Subject: CUP Application for Metro Transit Park and Ride at  
I-94 and Manning Avenue  
Lot 1, Block 1 of Four Corners 2<sup>nd</sup> Addition to the City of Lake Elmo

Re: Metro Transit Park & Ride at I94 and CSAH-15  
Engineering Plan Review

**To:** Ken Roberts, City of Lake Elmo Planning Director  
**From:** Lucius Jonett, Wenck Landscape Architect  
**Date:** March 29, 2019  
**Subject:** City of Lake Elmo Landscape Plan Review  
Metro Transit Park and Ride, Review #1

LANDSCAPE PLAN

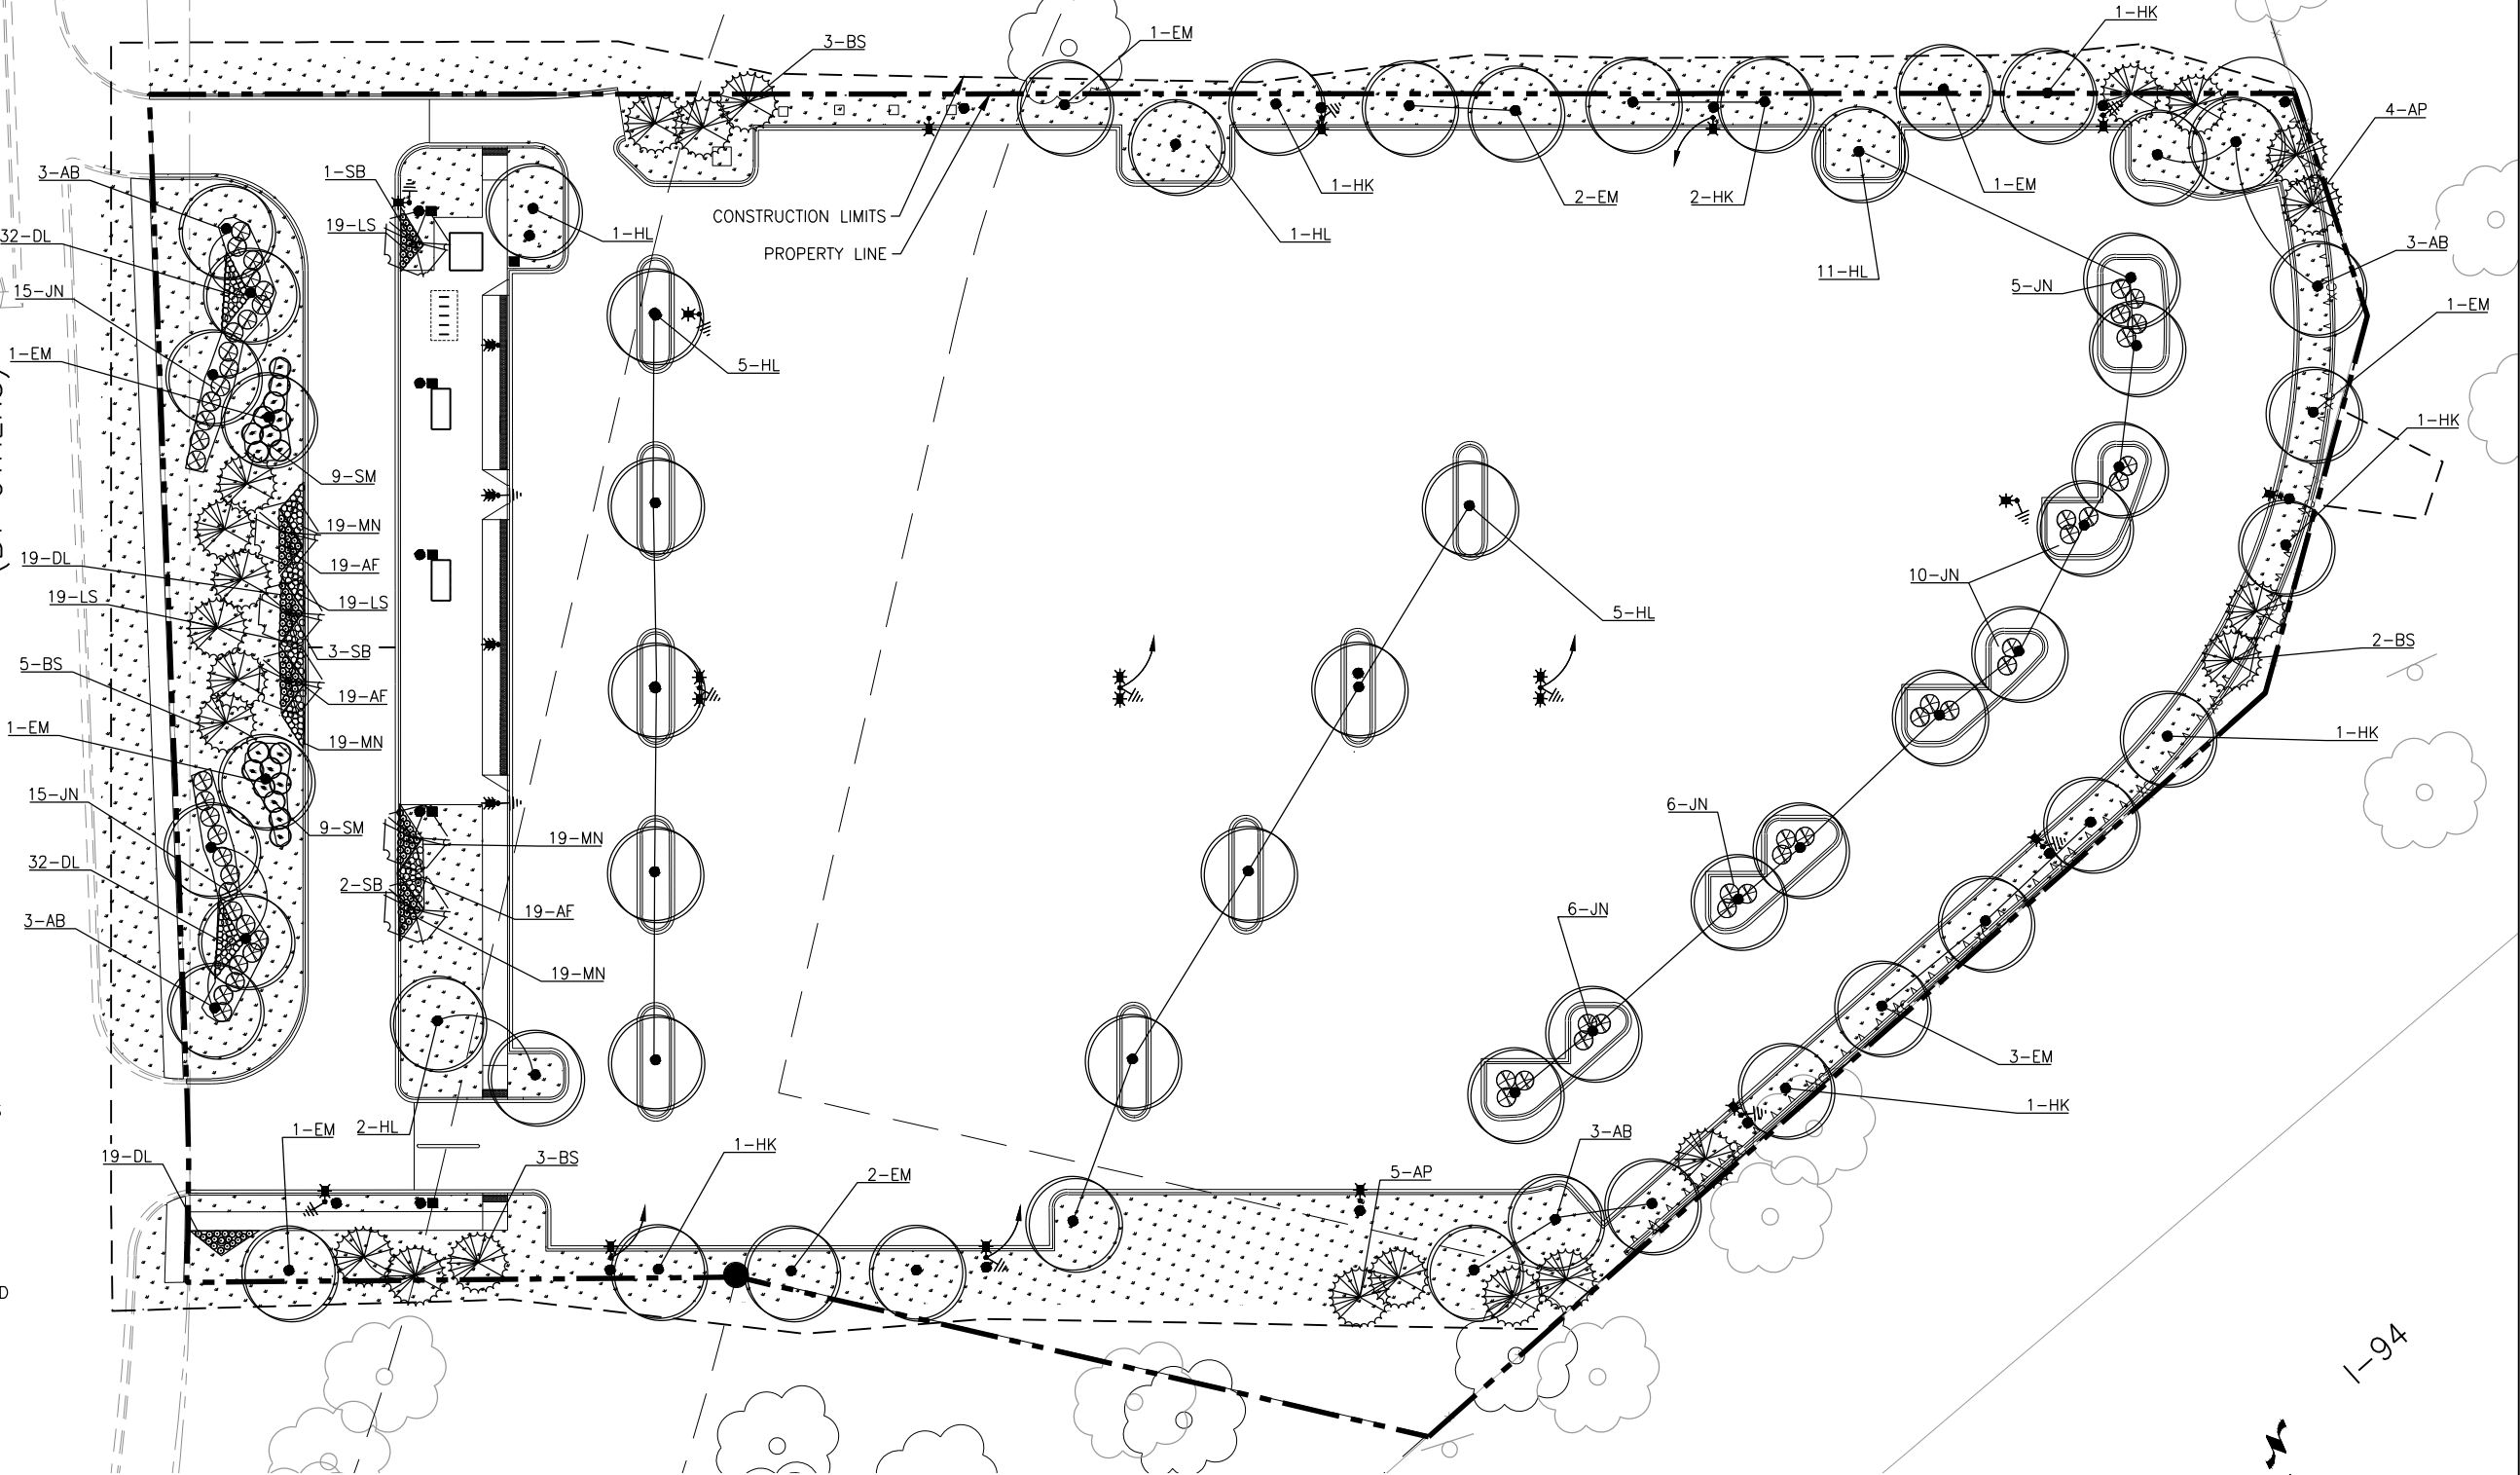
- L1.0. Landscape Plans. All proposed utilities must be shown on the landscape plans and all trees relocated to maintain 10 feet of separation from all public utilities.

- A. A landscape plan has been submitted that **does not** include all requirements.
1. Utilities are not shown on the landscape plan to review for tree placement conflicts.

1. Submit a revised landscape plan showing locations of utilities to review that all trees are 10' minimum away from utility lines.

I-94 AND MANNING AVENUE PARK AND RIDE STATION  
11530 HUDSON BOULEVARD NORTH  
UTILITY PLAN  
LAKE ELMO, MINNESOTA 55042

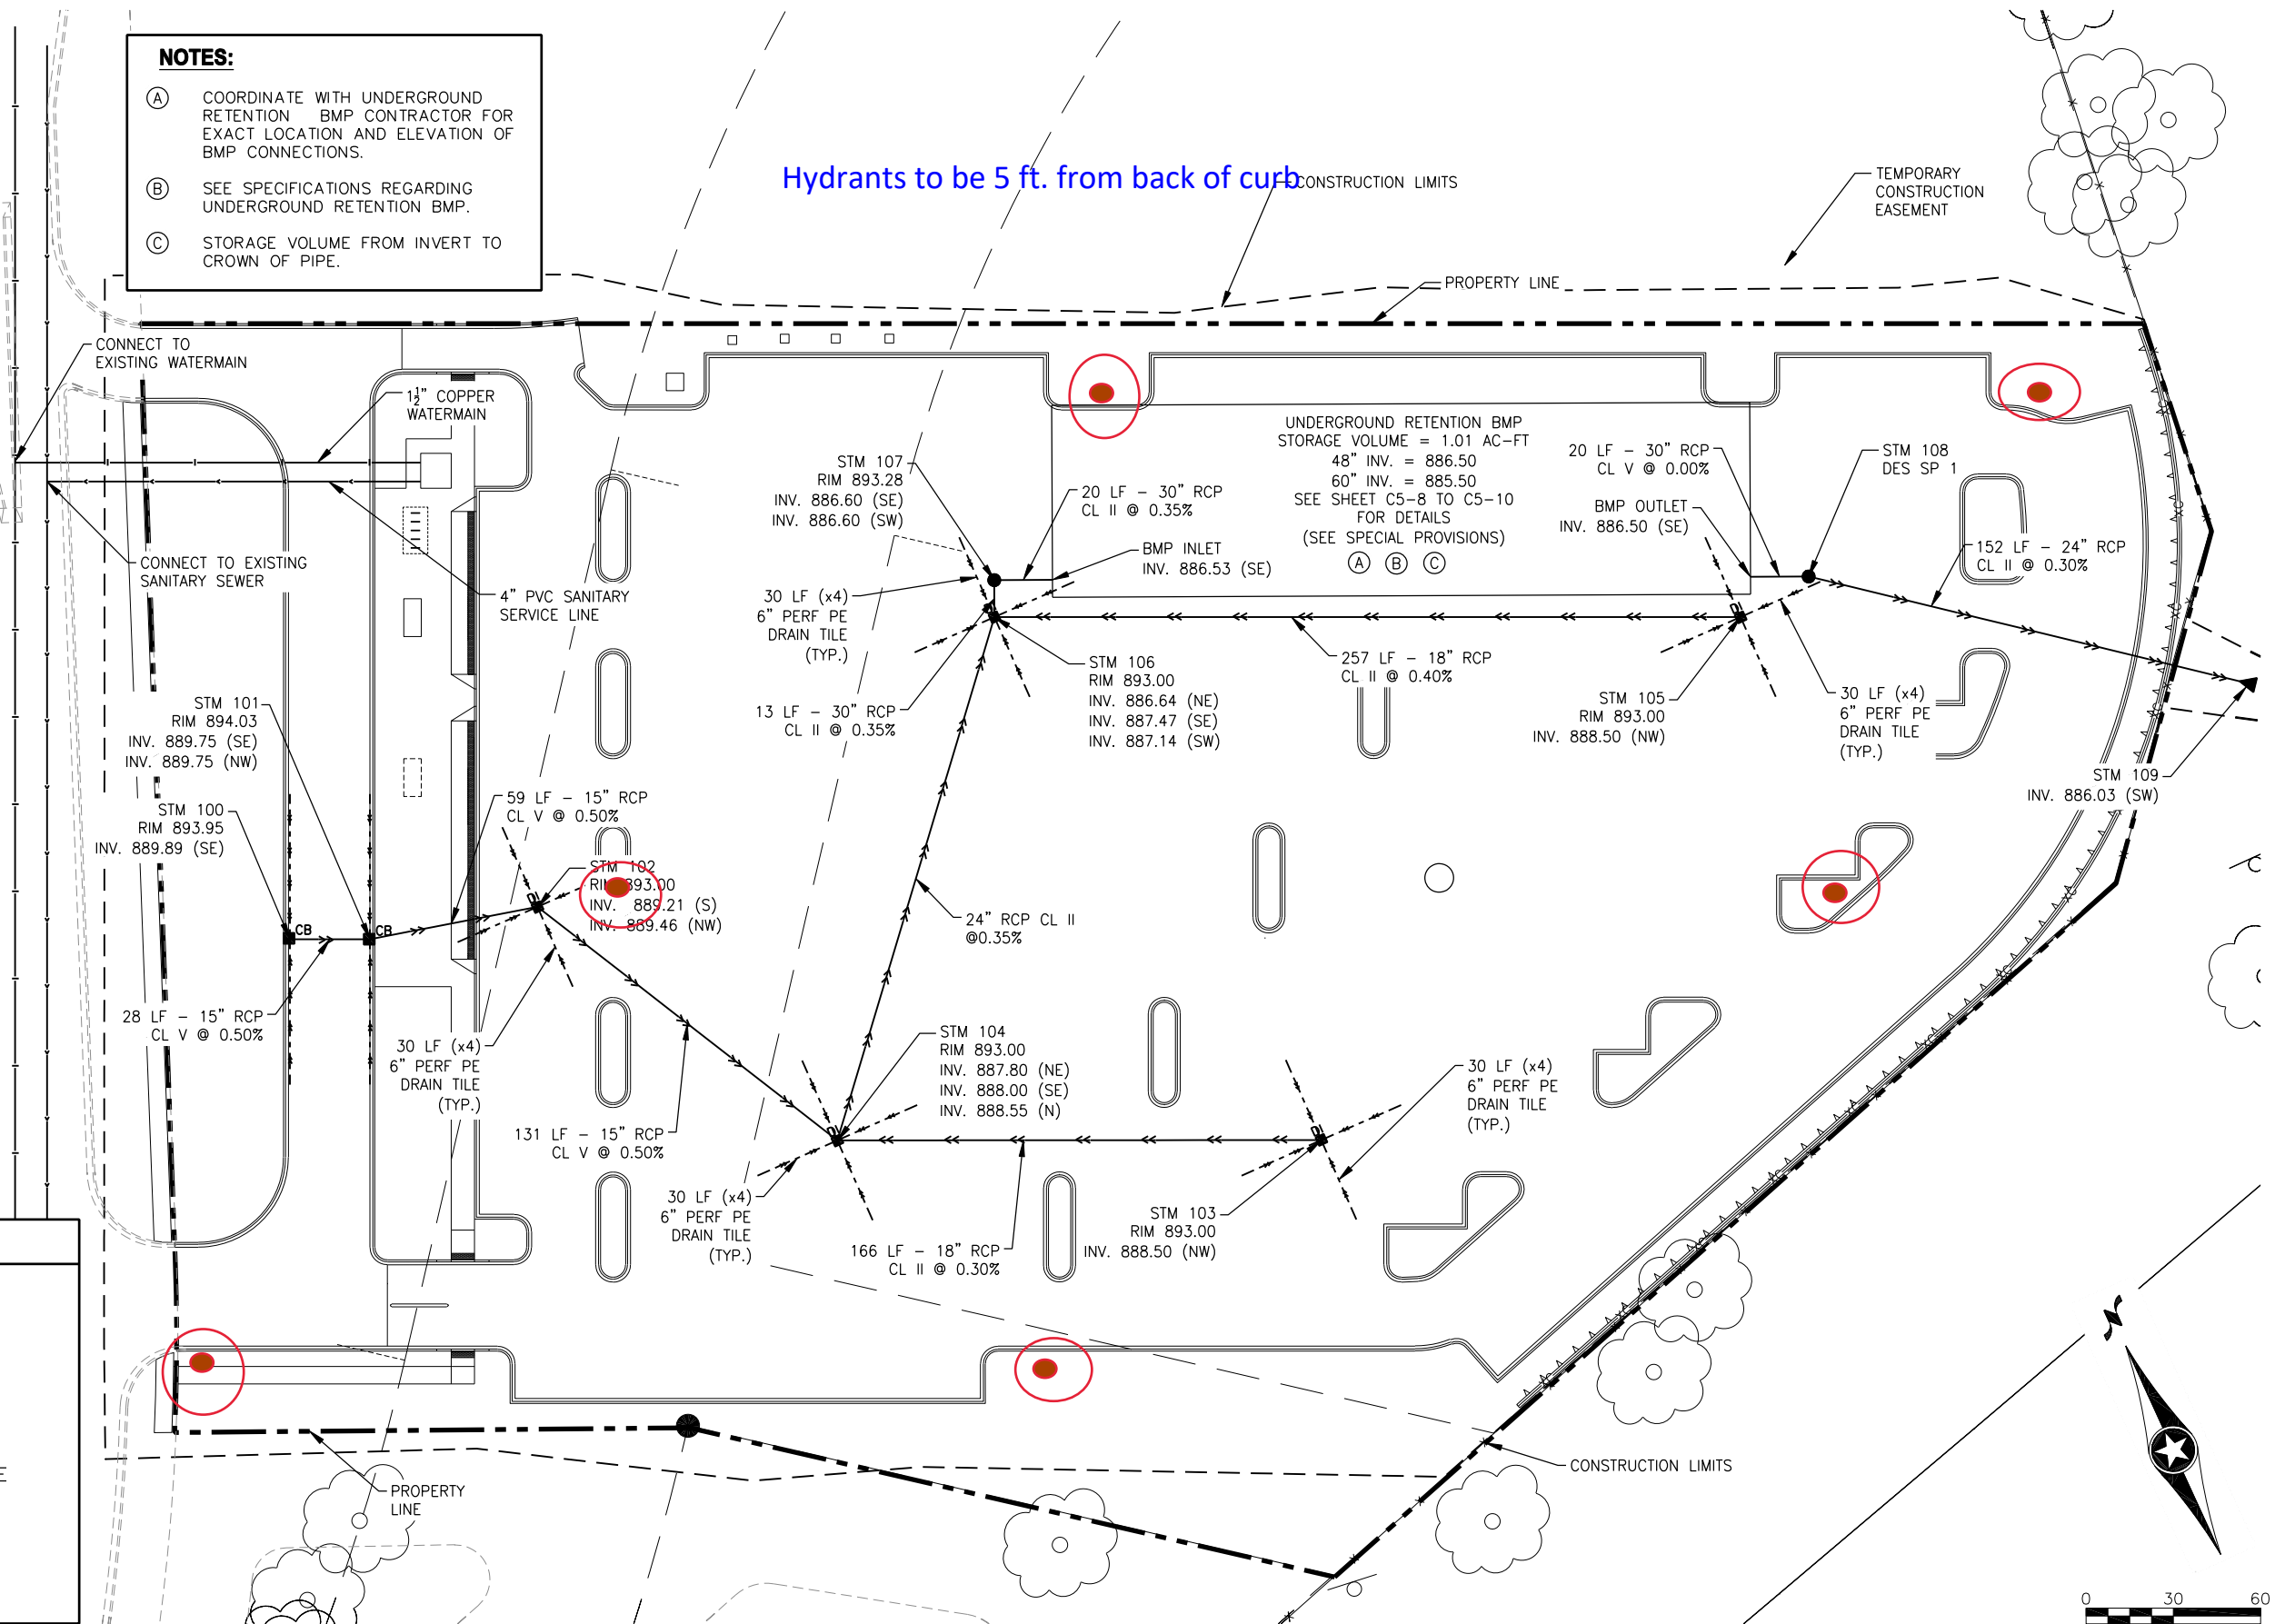
- C4.0. Revise the utilities shown in Hudson Boulevard from "existing" to "installed by others".
- C4.0. Utility Plan. Add hydrants interior to the site as required by the Lake Elmo Fire Department. See attached plans showing required locations.

- C4.0. Utility Plan. Revise plans to extend 8-inch watermain interior to site to each hydrant and create a looped main configuration. Update the plans to show a minimum 30-foot utility easement centered over all watermain and hydrants. Easement must extend minimum 15-feet from all pipe and hydrants.
